Parts Bulletin

Group	Number	Version
P-44-1	8	01

Shift mechanism, shift cone & shoe

Models: Sterndrives, Saildrives, Inboards

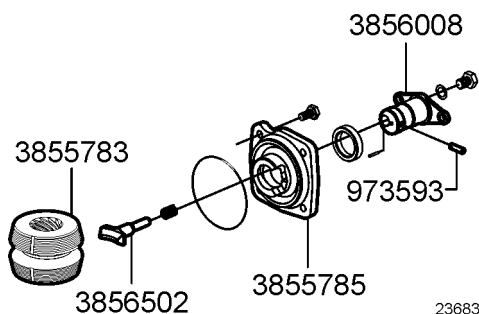
The shift cones (sliding sleeves) listed in earlier catalogs have been replaced by an improved shift cone, 3855783. When using this new cone to repair earlier drives or transmissions, you must use new shift shoe 3856502 with the new cone. Do not use the shift shoe mated to the original cone or shown with the original cone in the catalogs.

Note! Use of these earlier shoes with the new cone could damage the cone. It may also cause poor shifting.

The improved cone and shoe were part of a group of new parts released to improve shifting. The new parts are shown in the diagram.

These newer parts replace many earlier shift parts. In most cases the earlier part is replaced by more than one of the newer parts. Always use all of the new parts specified in the replacement. The newer parts are designed to work together and can not be mixed with the older parts.

Earlier cones affected by this change are replaced in the parts systems. If an earlier cone is ordered the system will replace it with a new cone and new shoe.

The parts not listed in the illustration are the same for the newer and earlier versions of the shift mechanism.
